UNITED STATES PATENT AND TRADEMARK OFFICE

APPLICATION NO.	FILING DATE	FIRST NAMED INVENTOR	ATTORNEY DOCKET NO.	CONFIRMATION NO.
09/518,421	03/03/2000	Victor Rossin	805.300US01	6283

Office Action Summary

DETAILED ACTION

FIG. 17A*FIG. 11A**FIG. 11B*

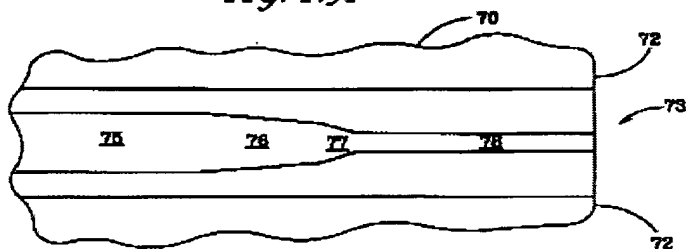
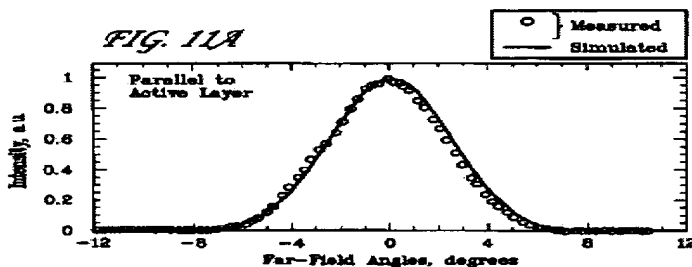
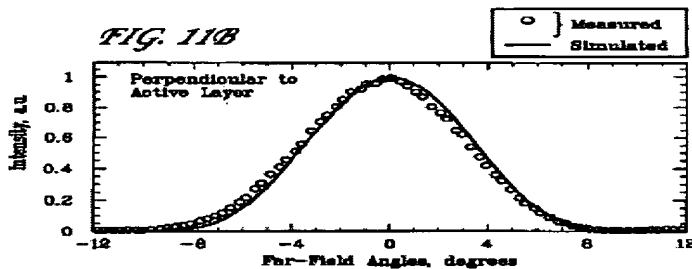
Figure 17 illustrates a semiconductor laser having a tapered waveguide for coupling to an optical fiber, the waveguide having three portions a wide portion (75), a tapered middle portion (76) and a narrow portion (78), as described in column 6 lines 30-39.

Figures 11A and 11B illustrate the far-field beam profile with a peak at 0 degrees and a constant slope, as described in column 9 lines 1-14.

Figures 2A-2C, 13A and 13B illustrate different widths for the tapered waveguide, as 2.4, 1.2, 0.7, 3.0 and 1.0 μm , respectively, which are within close range of the recited widths of applicant's invention.

Therefore, it would have been obvious to person having ordinary skill in the art at the time the invention was made to modify the semiconductor laser of Vawter et al by changing the size of the device and rearrangement of parts.

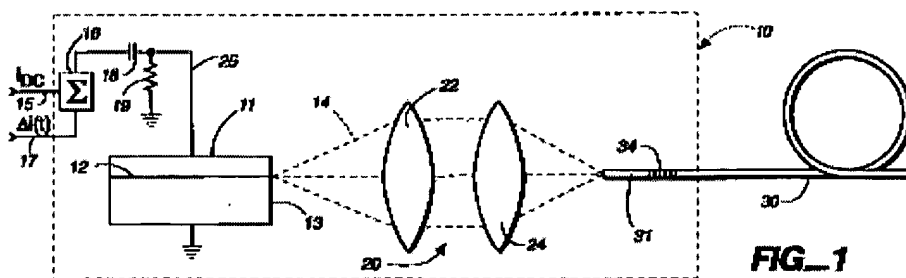
Ventrudo discloses coupling a laser system to a fiber having a grating.

Ventrudo illustrates in figure 1 a semiconductor laser (11) coupled via lenses (22,24) to an optical fiber (31), which contains a rare earth active gain medium (30) and a Bragg grating (34) positioned at 2cm to 3cm from the laser facet and having a reflectivity not exceeding 10%, as described in column 4 lines 19-67. In the abstract and columns 5 and 7 Ventrudo discloses the grating is provided at distance from the laser for causing the system to switch between the coherence collapse and coherence state.

Therefore, it would have been obvious to a person having ordinary skill in art at the time the invention was made to couple the laser system of Vawter et al with the fiber grating of Ventrudo because Ventrudo discloses coupling a fiber grating to laser system which will provide a broad band of wavelengths in a communications system.
